Notice and Agenda
Brigham City Planning Commission Meeting
Tuesday, October 6, 2026 6:00 PM
City Council Chambers, 20 North Main

SUBJECT: Report on Status of Use
Application #26-023 Fence Height Exception for Special Type Facilities
Monument Health Brigham City

PLANNING COMMISSION MEETING: October 6, 2026
APPLICATION TYPE: Administrative/Legislative
PLANNING COMMISSION ROLE: Recommending Body to City Council

PROJECT TITLE	HERON RIDGE TOWNHOMES PART OF THE NORTHWEST QUARTER OF SECTION 23, TOWNSHIP 9 N, RANGE 12E, MERIDIAN 10E SALT LAKE BASIN AND MERIDIAN BRIGHAM CITY, UTAH
DRAWING TITLE	PRELIMINARY PLAT

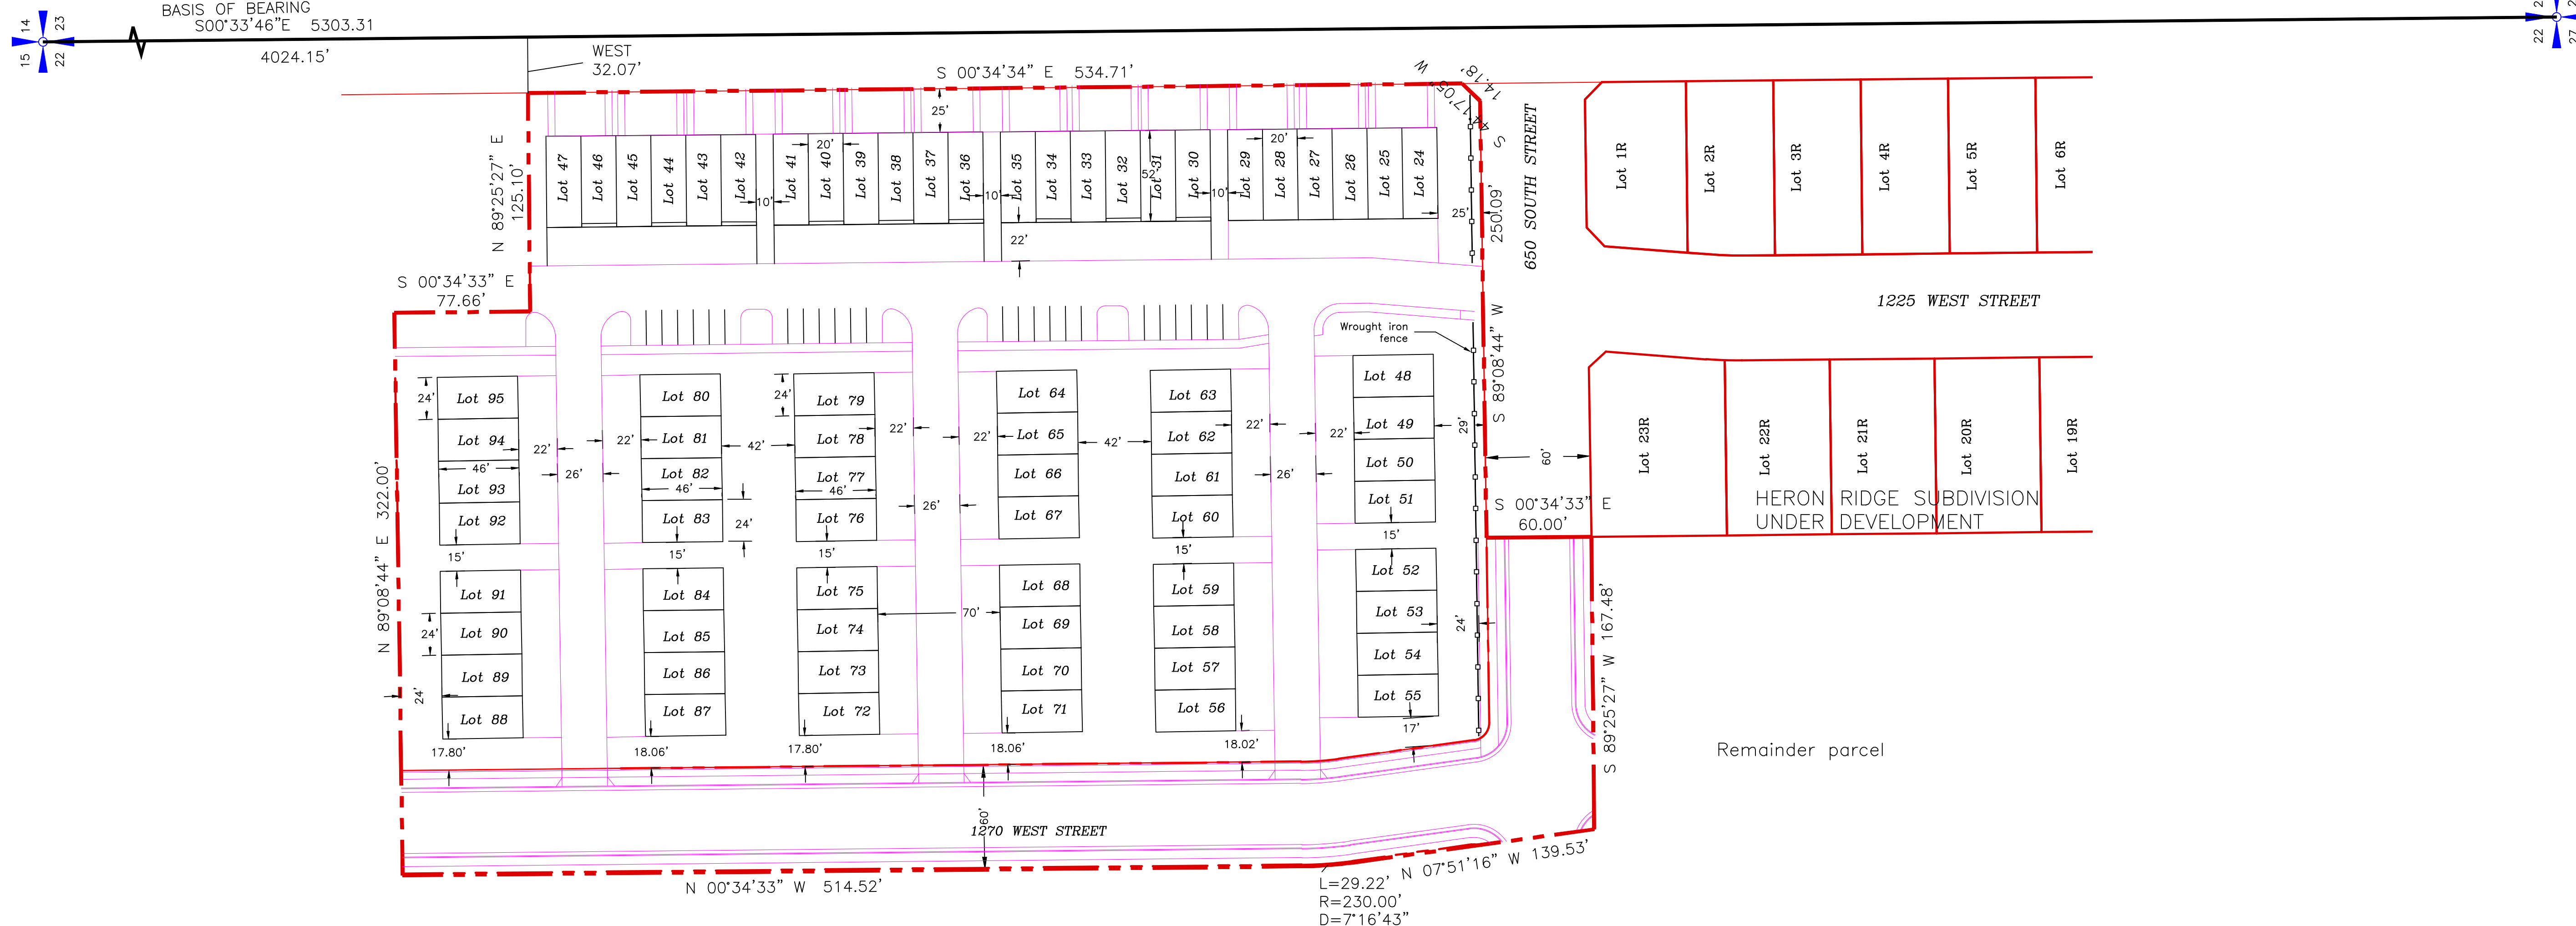
1. Overview.
 - A. The plans appear to show a total of 72 townhome units; however, the project notes identify 78 units. Revise the plans and project notes to reflect the correct total number of townhome units.

- B. Curb, gutter, and sidewalk along the west side of 1270 West (street coordinate to be confirmed as 1275 West or 1250 West) will not be installed at this time. Provide a minimum of 26 feet of drivable surface to meet Fire Code requirements.

- C. Please verify and correct the quarter section reference. The plan identifies the project as being within the Northwest Quarter of Section 23, while the Boundary Legal Description references the Southeast Quarter of Section 22. Revise as necessary for consistency.

2. Street number. 1270 should either be 1275 or 1250 West depending closest coordinate with other phases. Provide an updated concept so we can assign the appropriate street coordinate.

5. Drawing No. 1.
 - A. Typical Drive Aisle Cross-section. Include the full dimensions for the private street width and driveway width (minimum 22 ft between garage and back top of concrete ribbon curb).

- B. Typical 60' Road Cross-Section-650 South. Please label park strip, 10' path, and show location of wrought iron fence. Fence should be one foot off of sidewalk/path so pedestrians and bicycles don't hit the fence or get their handlebar caught in the fence.

- C. Landscape. Update landscape plan. Provide actual plans to be submitted with final plat application.
 - D. 1200 West.
 - A. Show and label wrought iron fence with gabion columns.

- B. Units 24 – 47. Show walkways connecting to a pathway behind the fence with tie into the 650 South 10 ft path.
 - E. Guest Parking. Label and provide a note to sign guest parking. Also provide, number of required number spaces and provided spaces.

- F. Units along 1270 (1275 or 1250) W. Provide a minimum 20 ft setback from the public street.

20' R.L. TOWNHOME 6-PLEX (GYP)
REAR ELEVATION (TR) TRANSITIONAL

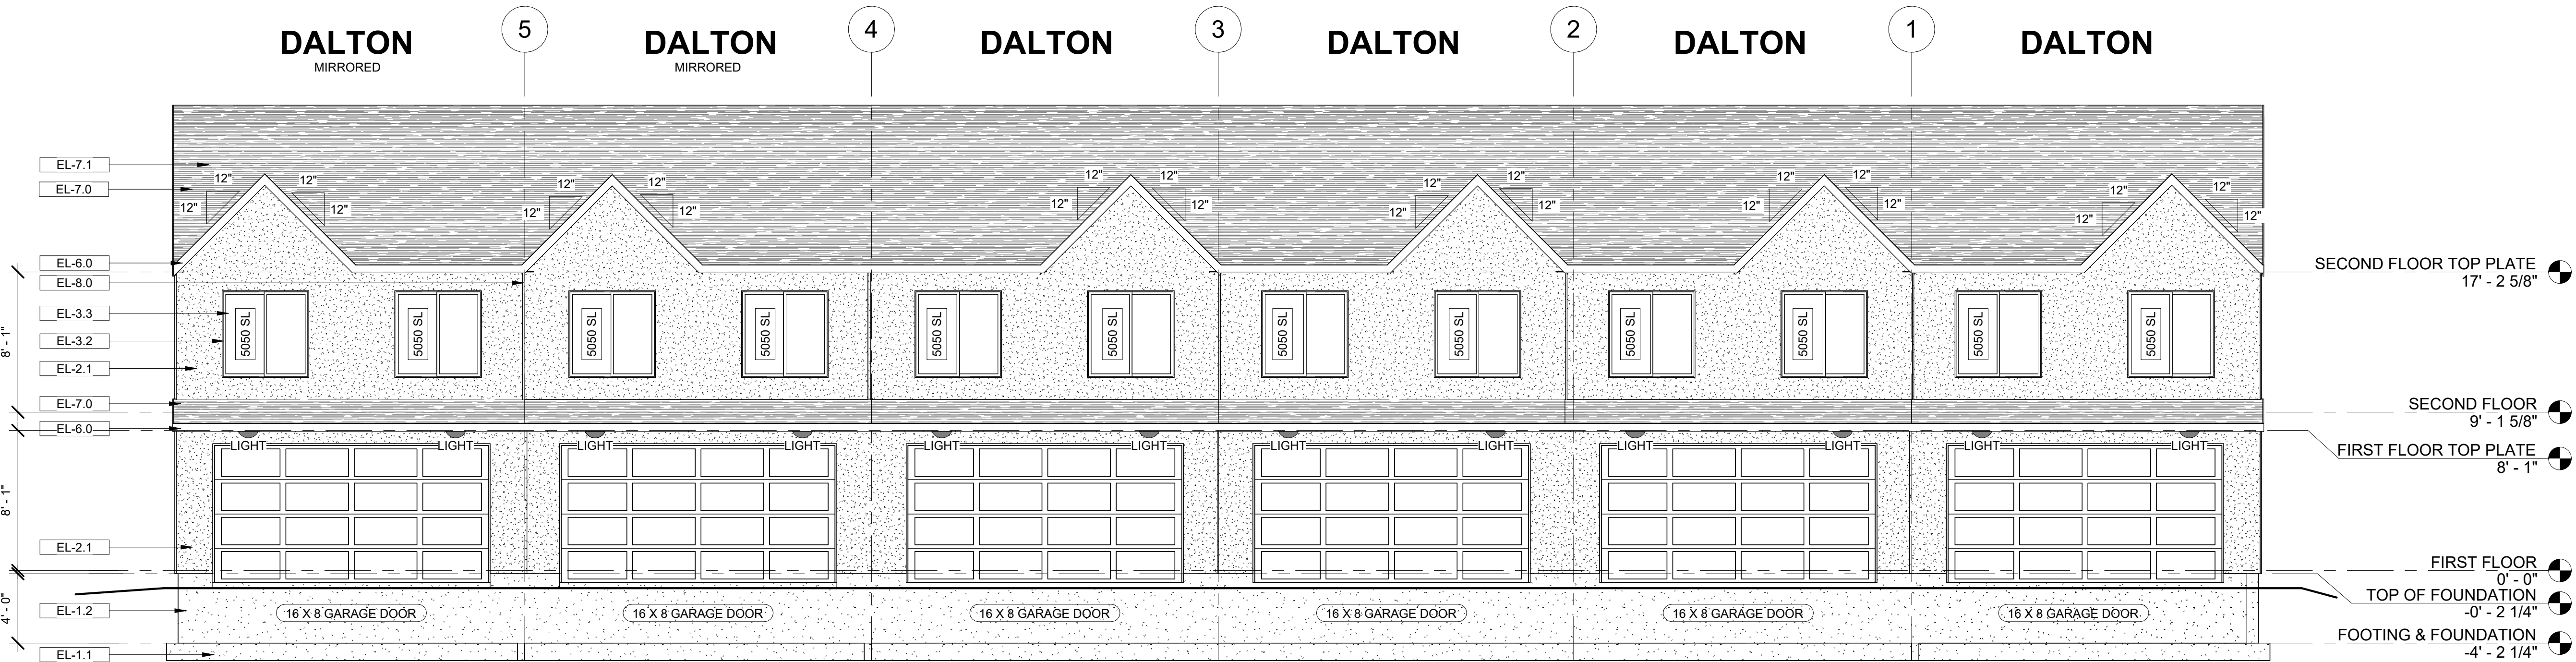
4. Rear Elevations along 650 South. Provide variation in color and material where the back of units will be visible along a key roadway into the project.
